MCU

Yanfeng

DRAWN	DATE	SHT	OF
Zhang Kai	2022/02/21	6	8

WDT

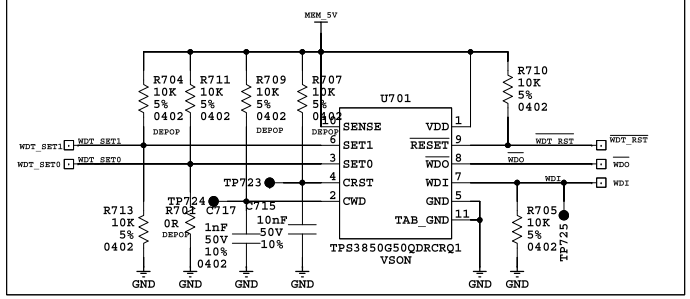
No.	DESCRIPTION	AUTHOR/DATE
1	Change WDT block to TPS3850	Zhang Kai/20211109
2	Add TP706 connect to WDT_SET1	Zhang Kai/20211109
3	change TP702 connection to WDT_SET0	Zhang Kai/20211109
4	U700 pin15 is changed to HEAT_LED_EN	Zhang Kai/20211109
5	U700 pin16 is changed to LED_AD	Zhang Kai/20211109
6	U700 pin17 is changed to HEAT_SIGANL_IN	Zhang Kai/20211109
7	U700 pin33 is connected to WDT_RST;	Zhang Kai/20211109
8	U700 pin35 is connection deleted	Zhang Kai/20211109
9	U700 pin42 is connected to WDT_SET0	Zhang Kai/20211109
10	U700 pin43 is connected to WDT_SET1	Zhang Kai/20211109
11	Move WDT_RST to pin47 to avoid the impact of MEM5V overvoltage	Zhang Jiahe/20211111
	Add R715	Zhang Jiahe/20211111
	C715 changed to 1nF	Zhang Kai/20211116
	Changed TPS3850H01 to TPS3850G50	Zhang Kai/20211122
	Changed R702,R703,R704,R705,R706,R707,R710,R711 to LHL[illegible]	Zhang Kai/20211209
	Changed C717 to 1 nF	Zhang Kai/20220217

17	Changed C715 to 10 nF	Zhang Kai/20220217
18	Delete TP706 ,connect WDT_SET1 to TP702	Zhang Kai/20220221
